DELEGATED REPORT

Application Reference:	PL/2023/01779 and PL/2023/02309
Application Type:	Planning Permission and Listed Building Consent
Site Address:	Front Lodge, Lacock, SN15 2NX
Proposal:	Proposed extension and associated works (resubmission of PL/2023/03570)
Recommendation:	That Planning Permission and Listed Building Consent is GRANTED

Figure 1: PL/2022/03570 & PL/2022/03751 LBC – proposed extension and double garage

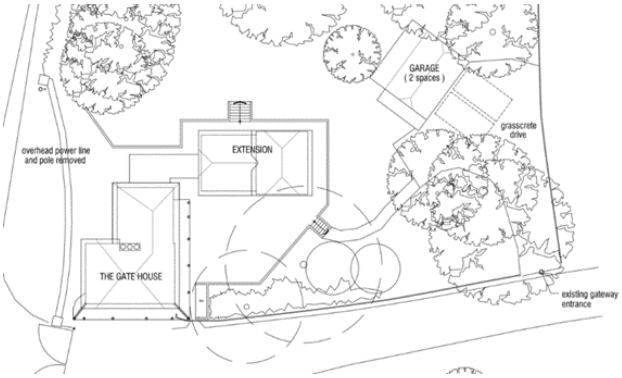
The sites planning history shows a recent planning application ref. PL/2022/03570 & PL/2022/03751 LBC, for the proposed extension, construction of double garage and associated work - withdrawn. The applicant withdrew the application due to concerns brought up by the Conservation Officer with regard to the extension to the listed building. Plan excerpts are provided in figure 1 below.
